MEMORANDUM

DATE: February 19, 2009

SUBJECT: Environmental Review for New Hampshire Avenue/ICC Interchange and Cape May Road Cul-de-sac in Upper Paint Branch Special Protection Area

Figure 1

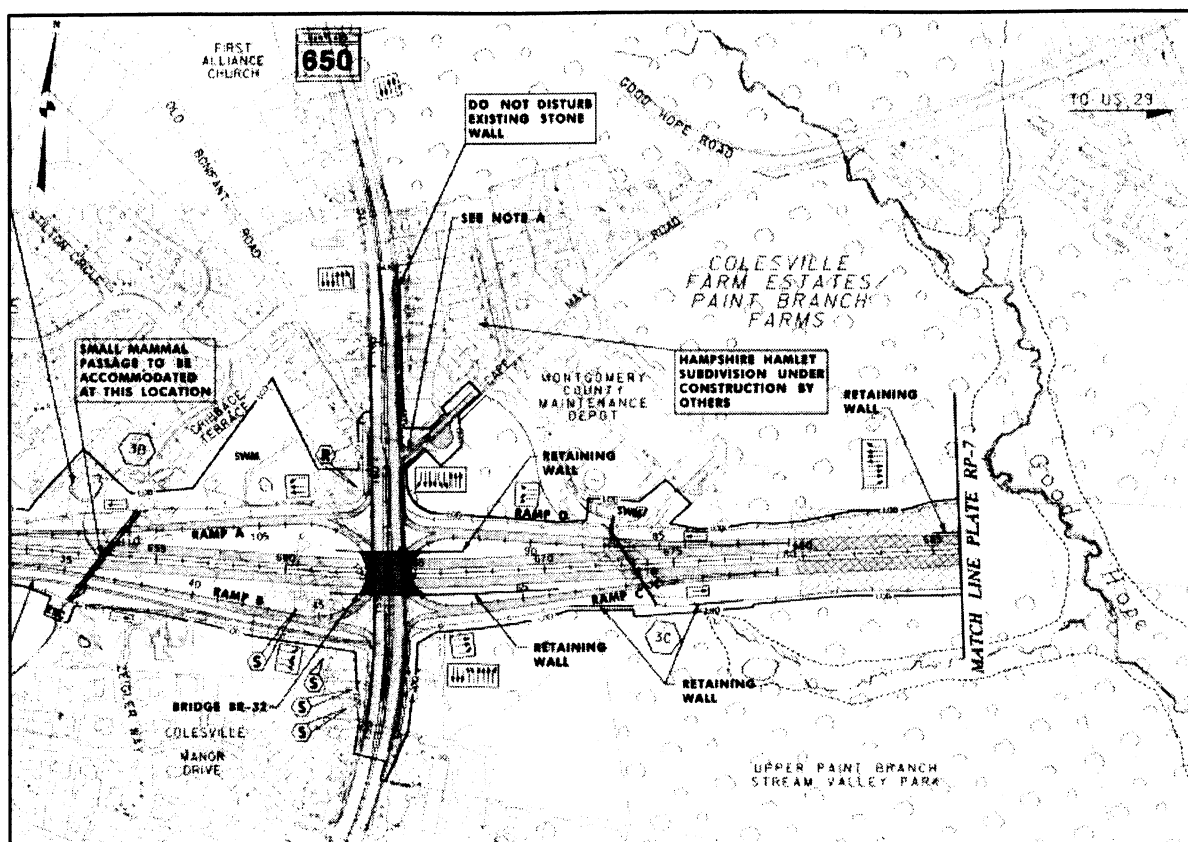
1. Final plans for the Cape May cul-de-sac (including sidewalk re-construction) should show no net gain of impervious surfaces within the Special Protection Area (SPA), consistent with the Board's action on July 31, 2008 requiring County Department of Transportation (DOT) to comply with Environmental Overlay Zone requirements for the existing sidewalk on this county-owned road.
2. Final plans for the Cape May cul-de-sac should include the re-establishment of a pedestrian connection between Cape May Road and New Hampshire Avenue that was recently installed by Montgomery County DOT due to strong safety concerns raised by

3. The re-established Cape May Road sidewalk shall be constructed of porous concrete or other in-kind material, consistent with the existing sidewalk.
4. Staff recommends that the County Department of Environmental Protection (DEP), in coordination with the Parks Department and SHA, should establish a water quality monitoring station within the tributary to Good Hope downstream of the Intercounty Connector (ICC) Limit of Disturbance (LOD). DEP would manage the station and the collection of water samples through an existing water quality monitoring contract, but funding would have to come from SHA.

A portion of the Cape May Road will be removed, and a cul-de-sac constructed in its place. The design-builder is required to re-establish the pedestrian connection between Cape May Road and New Hampshire Avenue. This pedestrian connection was recently installed by Montgomery County Department of Transportation due to strong safety concerns raised by the community. The current SHA concept plans do not show the sidewalk. Staff recommends that a safe pedestrian connection be maintained during construction.

Based on SHA’s narrative (but not shown on conceptual plans), the cul-de-sac will have approximately 5,170 square feet of new impervious area, and 4,265 square feet of existing pavement will be removed, leaving a net increase of 905 square feet. Staff has recommended to SHA that there should be a no net gain of impervious surfaces for the Cape May Road improvement (including sidewalk re-construction). This is consistent with the Board’s action on July 31, 2008 requiring County Department of Transportation (DOT) to comply with Environmental Overlay Zone requirements for the existing sidewalk on this county-owned road.

The cul-de-sac is shown on the attachment as being protected via a double row of super silt fence and silt fence. I would agree that this also meets the general intent of redundancy of control for the roadwork. All areas of disturbance must drain to acceptable sediment control devices.
